PROJECT: REPLACEMENT OF TWO (2) 1.5MVA STANDBY GENERATOR
SET AT POWERHOUSE AT SSS MAIN BUILDING

QUERIES/CLARIFICATIONS RAISED DURING THE PRE-BID CONFERENCE:

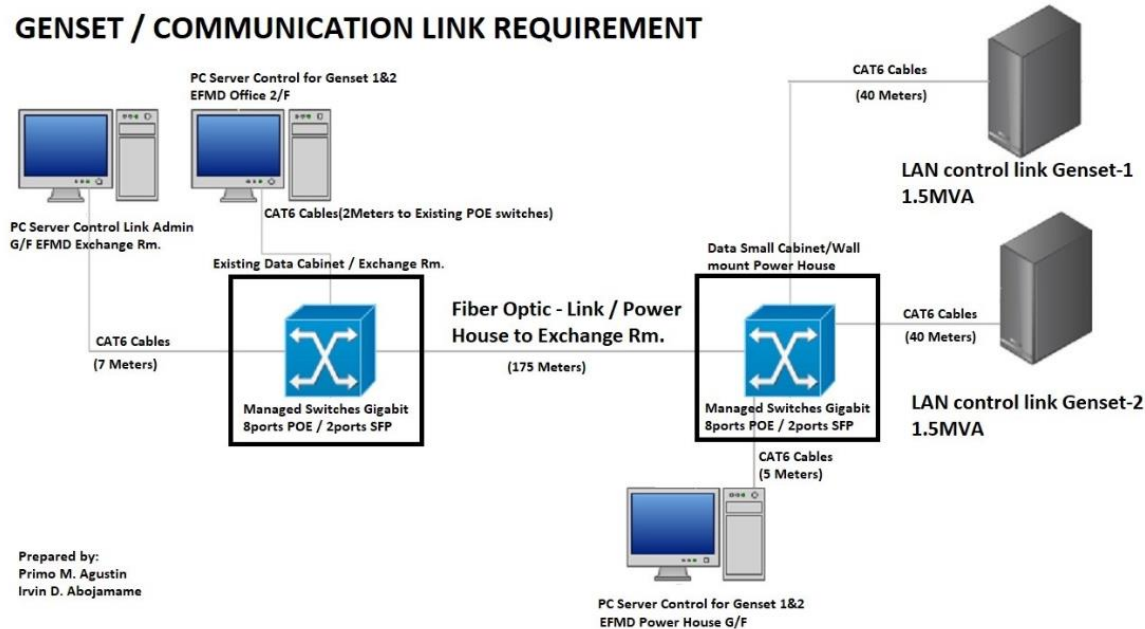
For the remote monitoring system of the generator sets, below is the single line diagram for reference. This will be supplied and installed during implementation.

Description	Requirement
PC Server- 3 Sets	Intel Core i7, SSD 500 GB, 8 GB RAM, 4GB Video Card, Win10 Licensed (embedded BIOS)
TV Monitor- 3 Units	55 inches
Fiber Optic Cable Outdoor - 200 Meters (appx.)	4 to 6 cores
CAT6 cables indoor- 100 Meters	UTP stranded
Data Cabinet- 1 Unit	Wall Mount / Small
Managed PoE Gigabit Switch 8ports with 2ports SFP- 2 Units	8 RJ45 Gigabit ports and multi support 2 ports SFP support 10GBe/1GbE Layer2 switching and security features Large PoE Power Budget
SFP Transceiver Modules- 4 pcs	BiDi SFP or Dual SFP that supports 10GBe/GbE
Patch Cable Fiber optic- 4 pcs., 1 Meter	any compatible to SFP Transceiver
